**Technical Service
Information Bulletin**

Title:
**NAVIGATION SYSTEM SHOWS VEHICLE
IN WRONG LOCATION**

Models:
**'06 IS 250/350 & '07 ES 350, GS 450h, GX 470,
RX 350, & RX 400h**

REVISSED
ELO13-06
ELECTRICAL

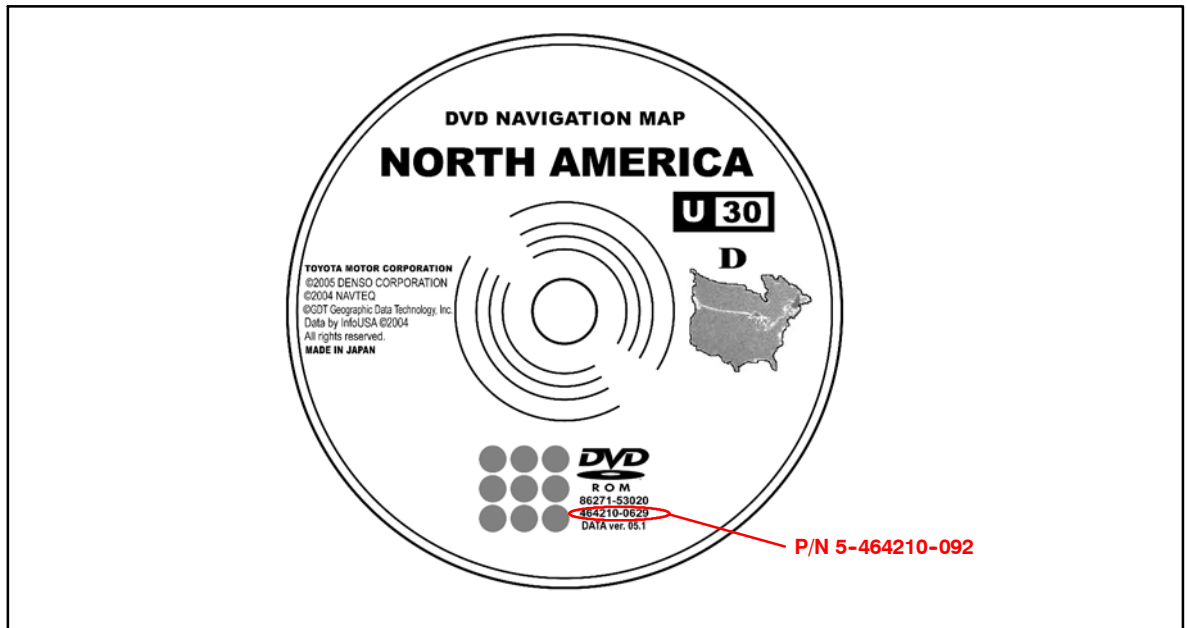
Identification Method The map disc supplier part number changed to 5-464210-092. Refer to the following illustration to locate the supplier's part number (directly below the OEM part number):
